## 5.3 T200644 PA - Construction of a multi-storey apartment building - 4-22 Rushgate St, Pakenham

That Council issue a Notice of Decision to Grant Planning Permit T200644 for the construction of a multi-storey apartment building at 4-22 Rushgate Street, Pakenham subject to the following conditions:

<b>APPLICATION NO.:</b>	T200644
<b>APPLICANT:</b>	Devcon Planning Services Pty Ltd
<b>LAND:</b>	L1420 - 1430 PS749784, 4-22 Rushgate Street, Pakenham VIC 3810
<b>PROPOSAL:</b>	Construction of a multi-storey apartment building
<b>PLANNING CONTROLS:</b>	<p><b>Zone:</b></p> <ul style="list-style-type: none"> <li>• Comprehensive Development Zone (Schedule 2)</li> </ul> <p><b>Overlays:</b></p> <ul style="list-style-type: none"> <li>• Development Contributions Plan Overlay (Schedule 1)</li> <li>• Land Subject to Inundation Overlay (partial)</li> </ul>
<b>NOTIFICATION &amp; OBJECTIONS:</b>	<p>Pursuant to Section 52 of the <i>Planning and Environment Act 1987</i>, the application was advertised by the placing of signs on site and sending notices in the mail to nearby property owners.</p> <p>Five (5) objections were received.</p>

Basement parking Level 1

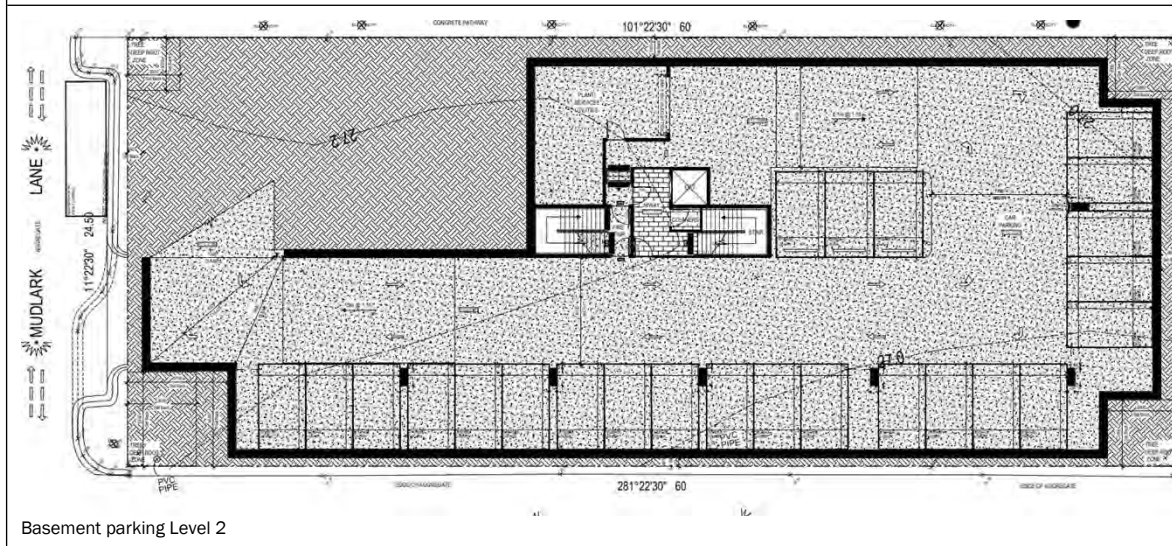
- g. That the storage lockers can be sufficiently accommodated (either demonstrating a 2.1 metre overhead clearance will be provided, or demonstrating the clearance arrangements implemented to show sufficient clearance will be available above the bonnets and the designation of forward in parking only).

- h. Amended swept path into car parking space 1 and 18 illustrating forward-entry ingress via a 3-point turn (without turn wheels from stop).
- i. Amended swept path from car parking space 1 illustrating egress via a 3-point turn.
- j. Amended swept path out of car parking space 25 illustrating egress via a 3-point turn.

### Roof top communal area

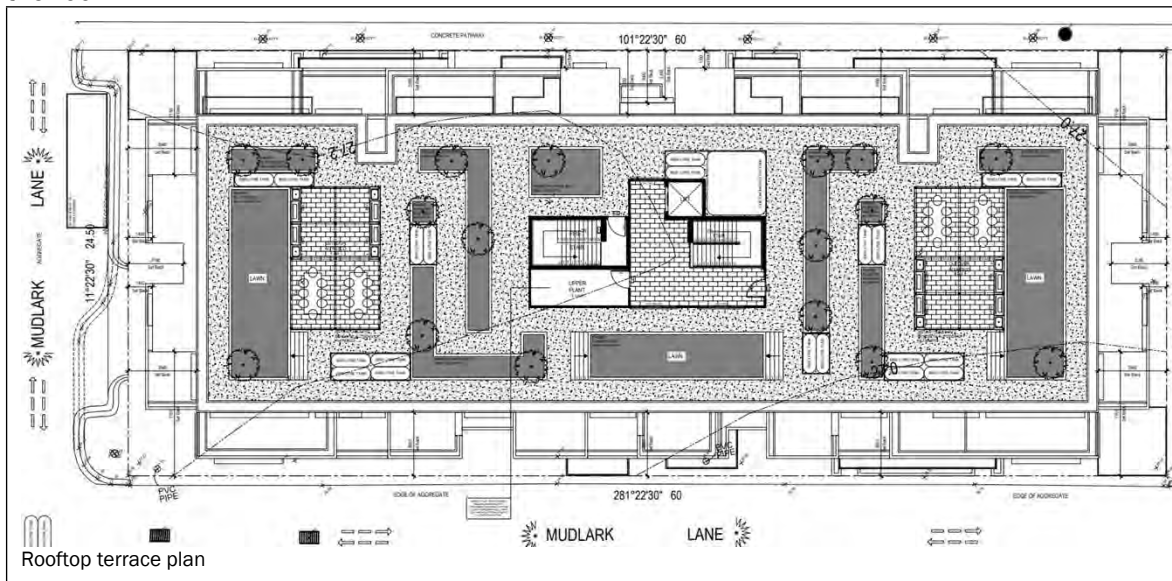
- k. The rooftop communal space further setback from the edge of the building to further prevent overlooking.

To mitigate the objectors concerns about overlooking, the applicant has agreed to reduce the area of the rooftop communal area, which will set it back further from the edge of the building ensuring that landscaping screening and the building line further intersect the line of sight from the rooftop into neighbouring properties.

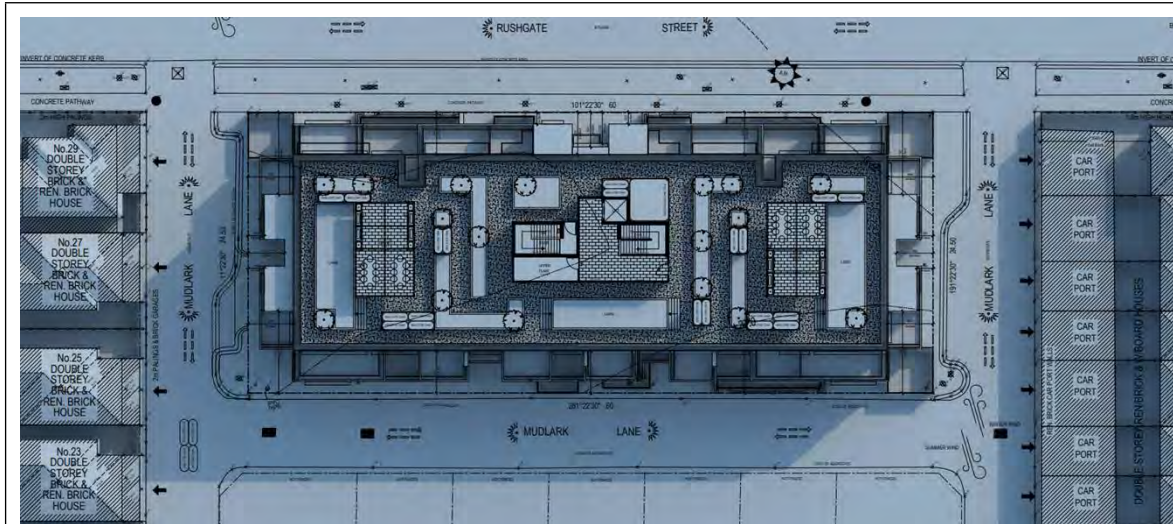
A number of objectors raised concerns about overlooking into the private open space.

According to the plans submitted, given the setbacks and screening proposed there should be no impacts to adjoining properties from overlooking. The setbacks of the apartment balcony's and roof top terrace from the neighbouring boundaries results in either the building or boundary fencing intersecting the line of sight into the private open space of neighbouring properties.

Where required, Conditions requiring screening can also be placed on the permit to ensure that overlooking does not occur.
